MCCD DESIGN REVIEW COMMITTEE
Zoom Video Conference

1. The Vine Apartments
184 East Vine Street
Mixed Use Development

Project #: 20-110

AGENDA ITEM #1

Figure 1: Proposed Fire Lane and loading/unloading zone

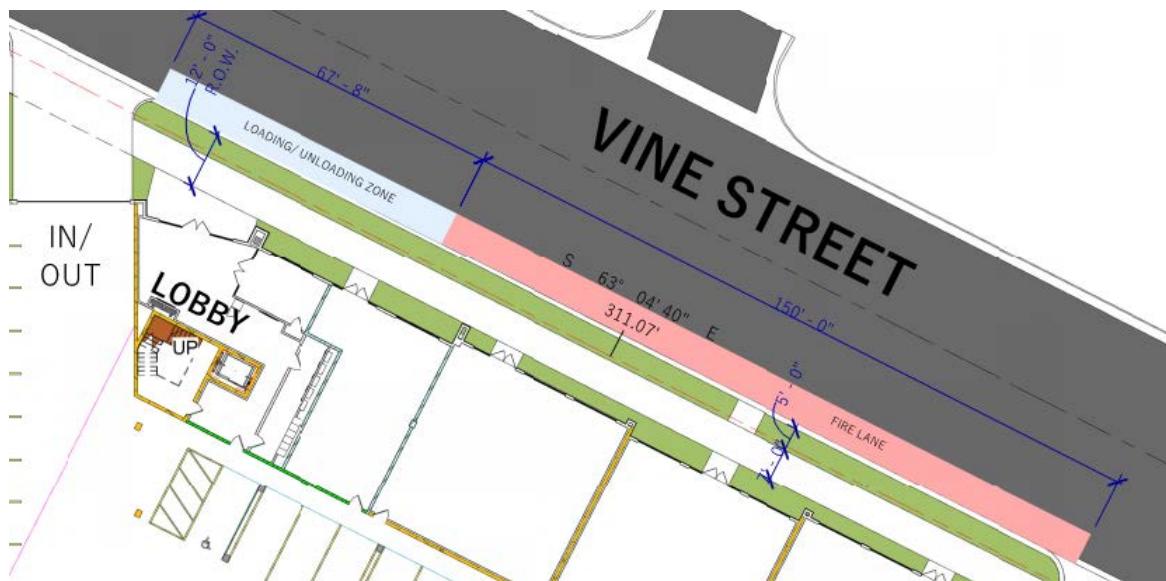
The applicants have proposed to mark the street frontage along Vine Street as a fire lane and for loading/unloading for potential deliveries (see figure 1). The Murray City Fire Department and Engineering Division have asked for additional space to be able to park emergency vehicles without impeding traffic on Vine Street. Planning Division staff has spoken to the applicant and they are looking into ways to provide for emergency vehicle access.

1. Fire Department does not see any access besides the road.
2. Applicant must either provide a pullout on Vine Street or provide a drive that connects the front and rear of the property without going through the garage.
3. Fire access must be provided to allow for Fire Department Connection and building access points.
4. Be aware of the height requirement for installing a fire pump for the riser.

2. The applicant shall meet all Murray City Fire Department requirements including the following:
 - a) Applicant must either provide a pullout on Vine Street or provide a drive that connects the front and rear of the property without going through the garage.

ELECTRICAL PHOTOMETRIC SITE PLAN

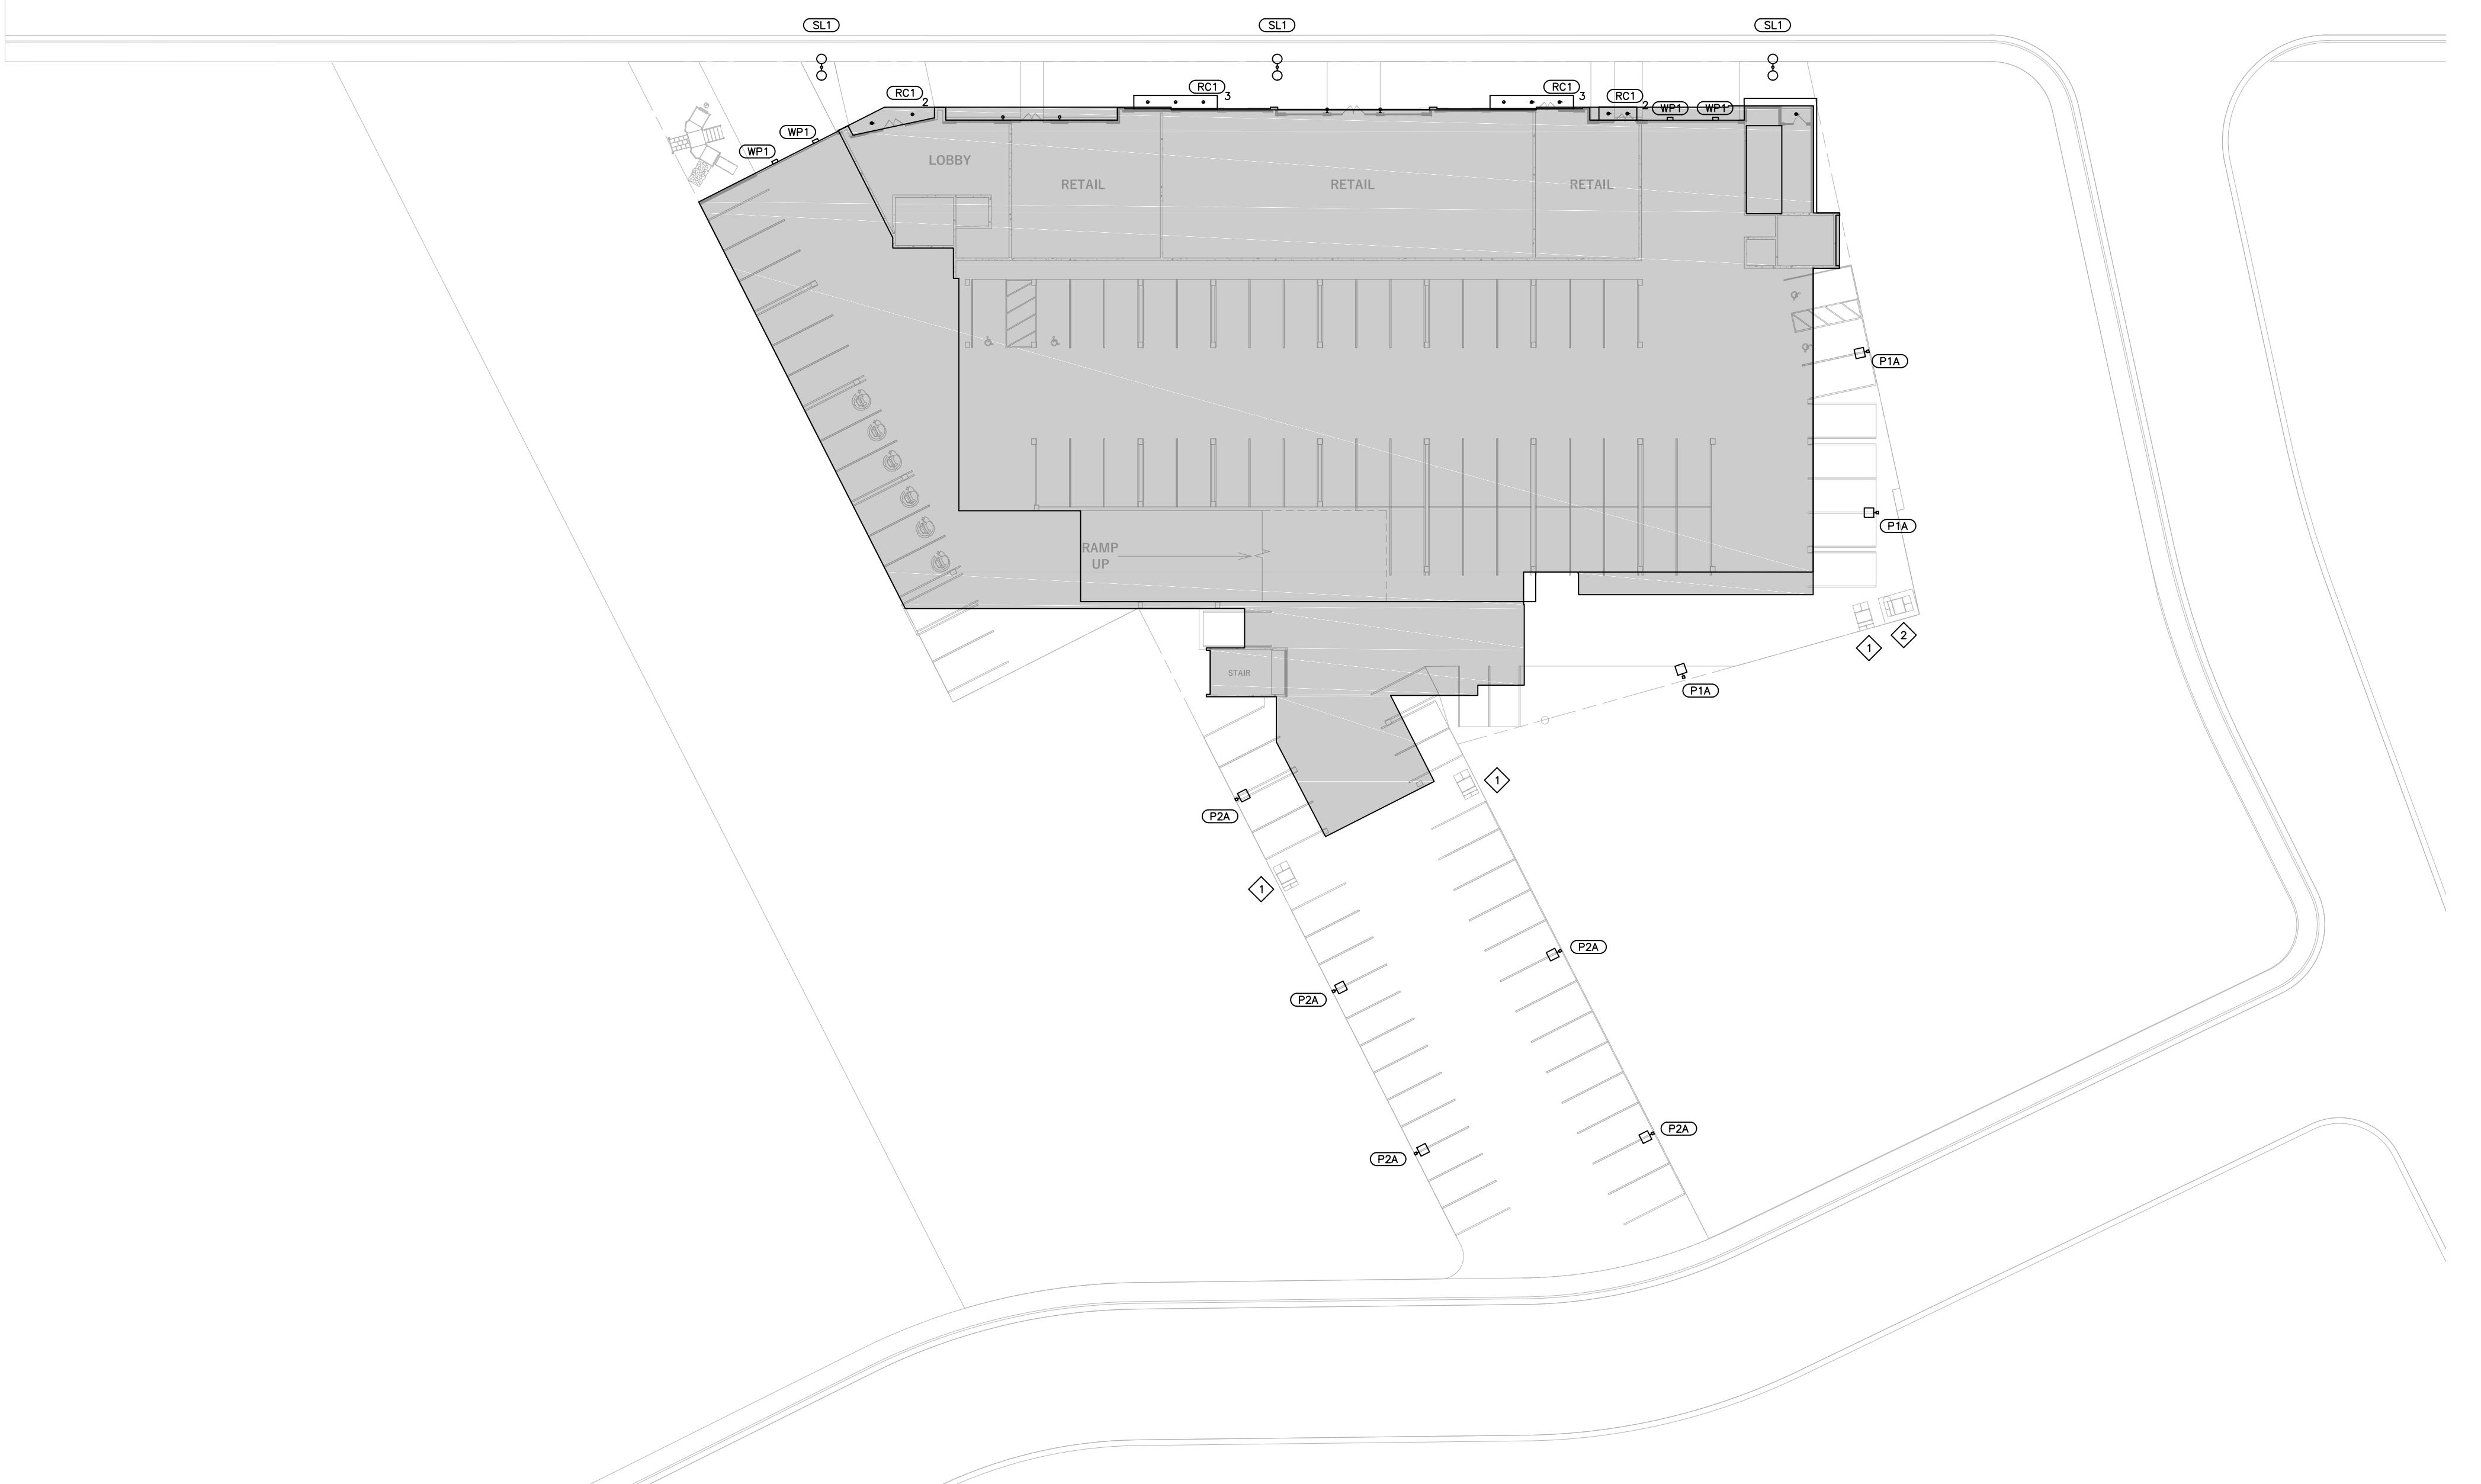
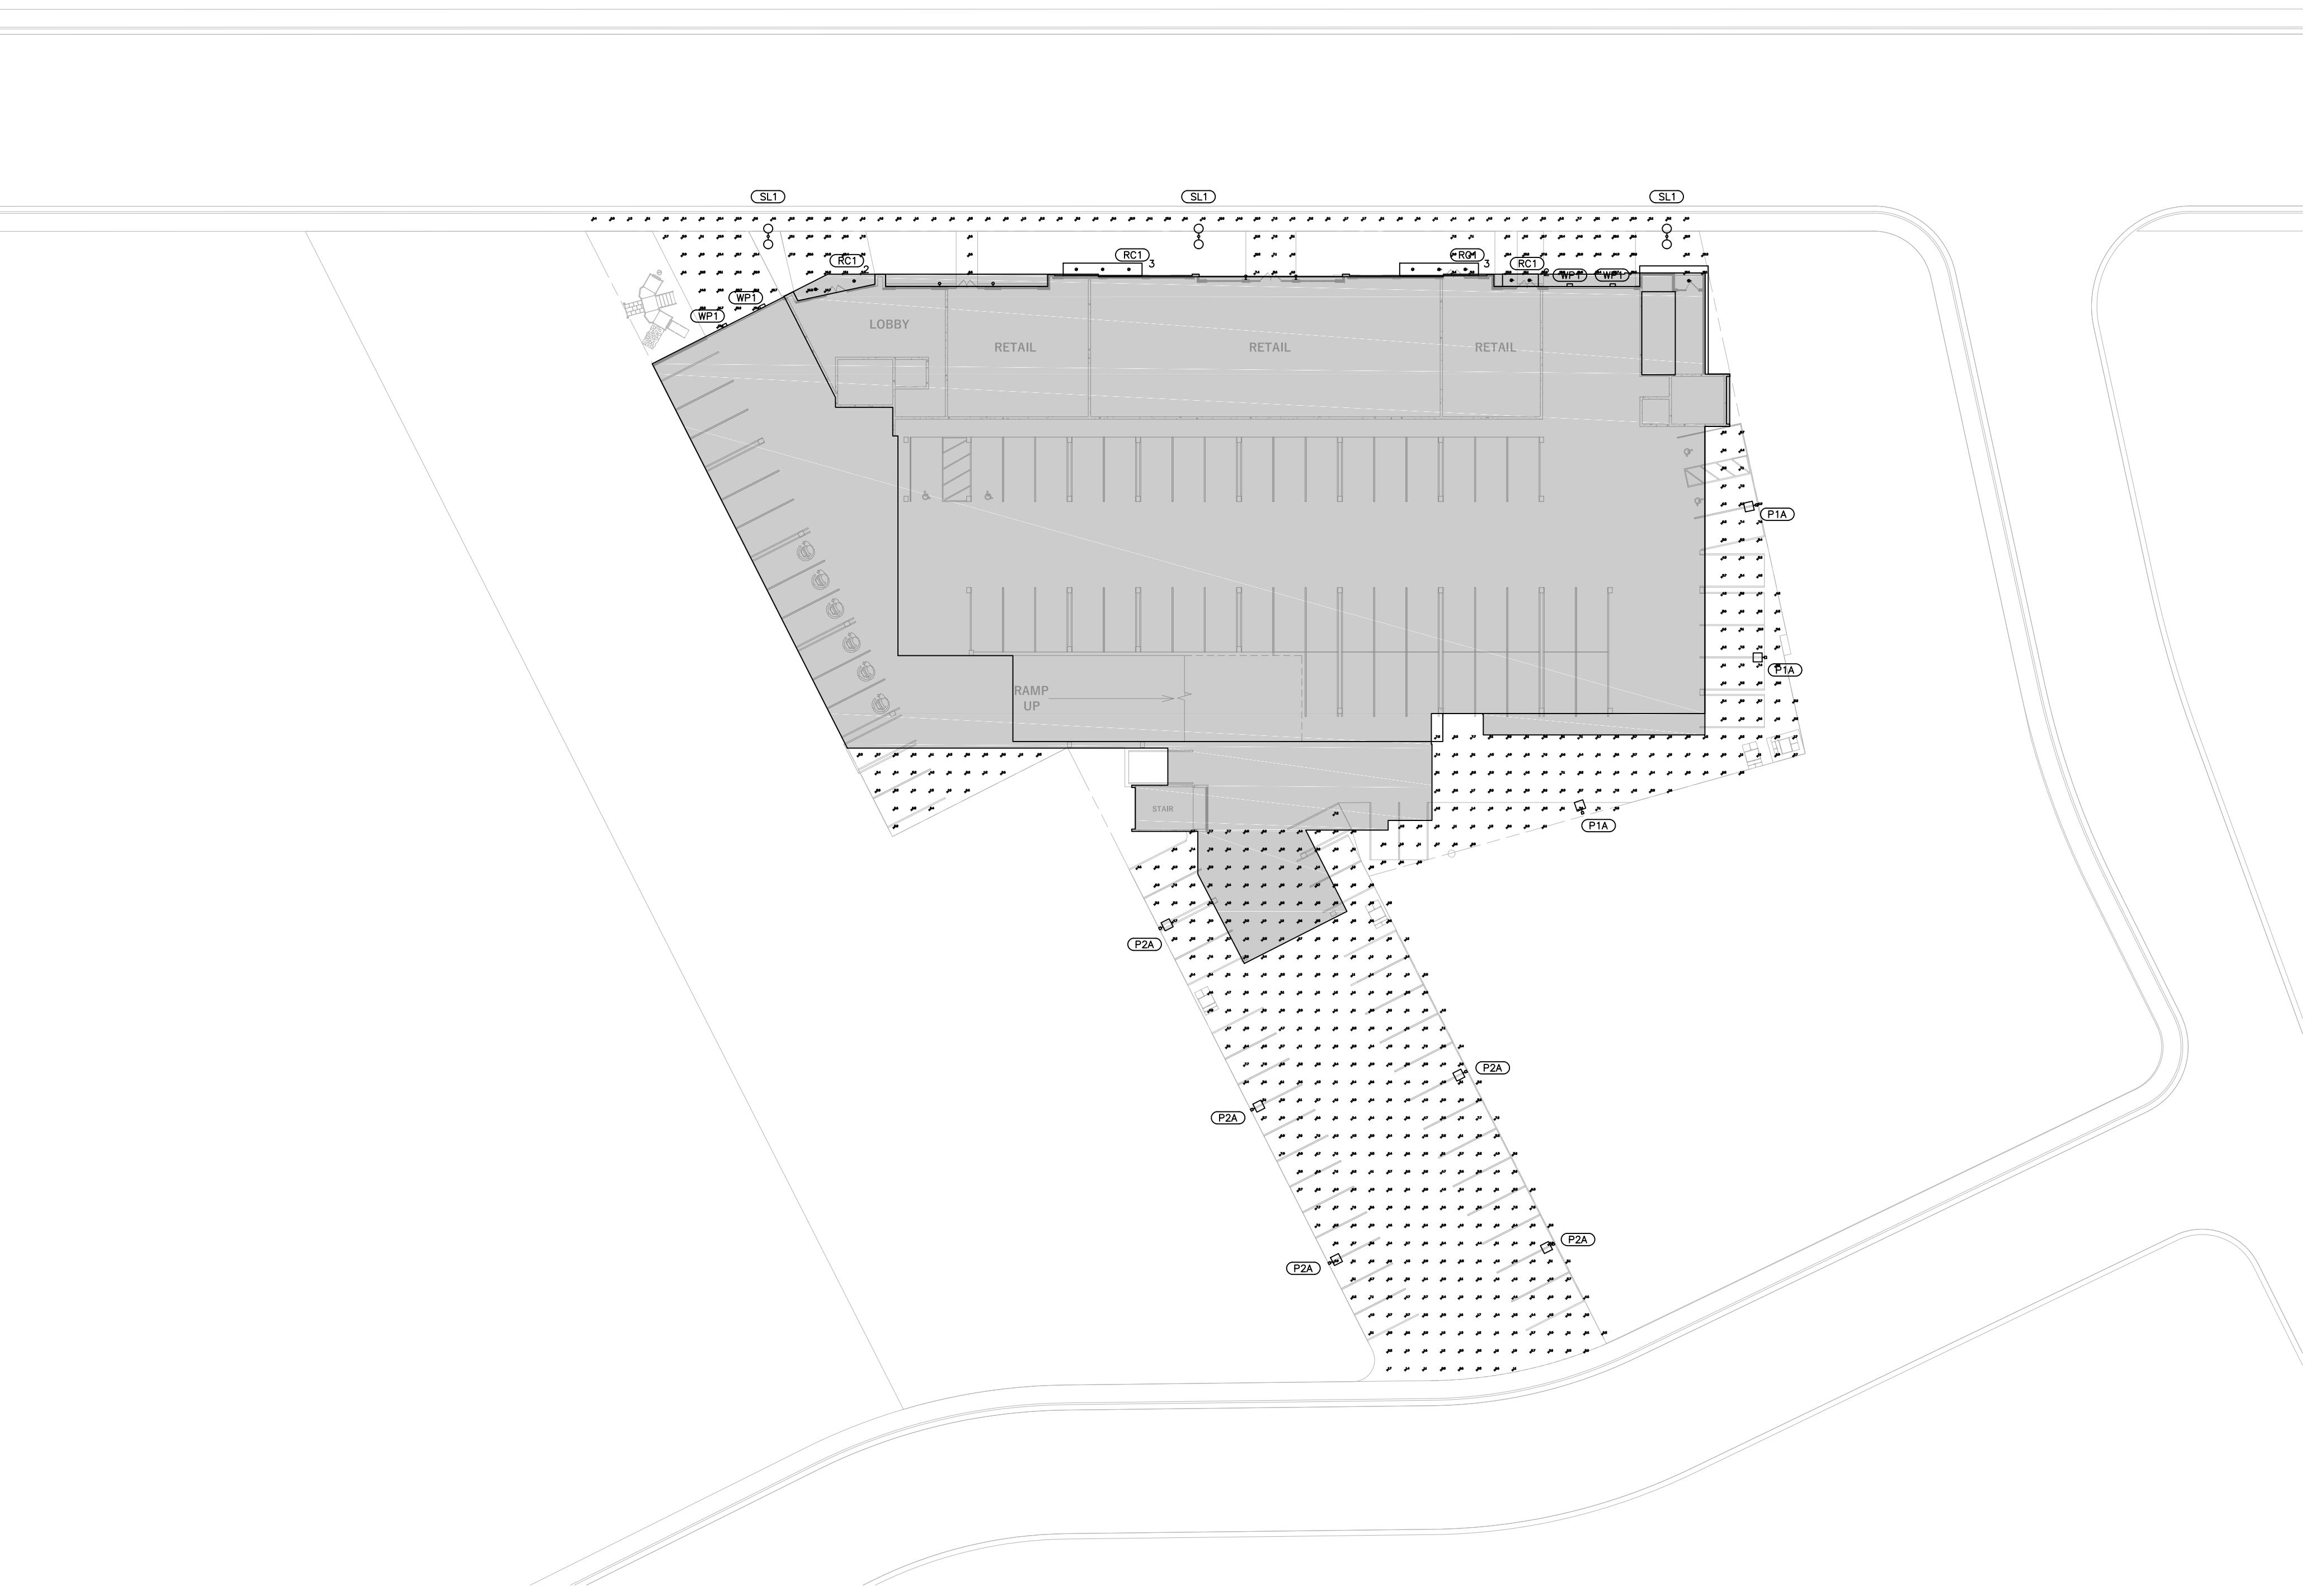
Staff has reviewed the proposed photometric plan that is attached to this report. The proposed lighting meets the standards of the Land Use Ordinance. Staff recommends that the applicants work with Murray City Power to provide the appropriate streetlights that will be required to be installed during the construction.
